Access Compliance Report Public Rights-of-Way (Curb Ramps)

Main Street: O_NEILL_DR Cross Street: ETON_PL Location: N

ADA ID: RPRK211103153053 Ramp Type: Type 4 - Parallel Initial Pass/Fail: Fail Overall Compliance: No Severity Score: 2

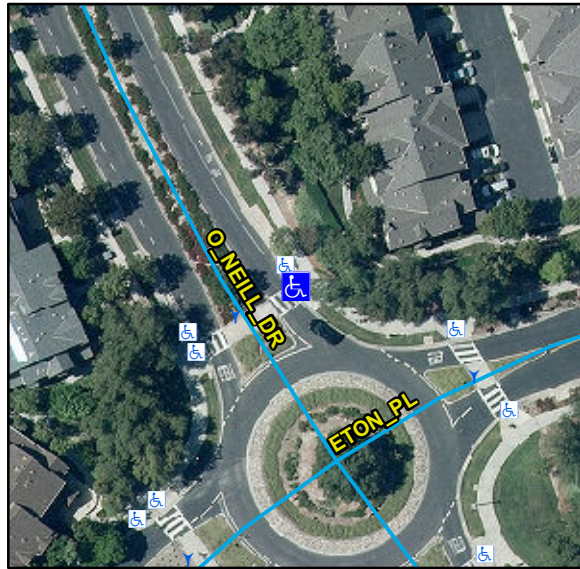
Compliance	Description	Data	Compliance	Description	Data
N/A	Ramp Length LT (in)	-9999	N/A	Ramp Length RT (in)	74
N/A	Ramp Width LT (in)	-9999	Yes	Ramp Width RT (in)	48
N/A	Ramp Run Slope LT (%)	-9999	Yes	Ramp Run Slope RT (%)	6.9
N/A	Ramp Cross Slope LT (%)	-9999	No	Ramp Cross Slope RT (%)	2.1
N/A	Landing Present	N/A	N/A	DWS Provided	N/A
N/A	Landing Length (in)	N/A	N/A	DWS Contrast	N/A
N/A	Landing Width (in)	N/A	N/A	DWS Length (in)	N/A
N/A	Landing Run Slope (%)	N/A	N/A	DWS Full Width	N/A
N/A	Landing Cross Slope (%)	N/A		DWS Offset Type	N/A
N/A	Landing Movement Obstructed?	N/A	N/A	DWS Offset Left (in)	N/A
	Landing Movement Type	N/A	N/A	DWS Offset Right (in)	N/A
N/A	Landing Shared	N/A			
N/A	Clear Space	N/A			
N/A	Clear Space To Crosswalk (in)	N/A			
N/A	Marked Crosswalk 1	Yes	N/A	Marked Crosswalk 2	N/A
	Crossing 1 Direction	W		Crossing 2 Direction	N/A
	Marked Crosswalk 1 Width (in)	145		Marked Crosswalk 2 Width (in)	N/A

Remove & Replace Entire Ramp.
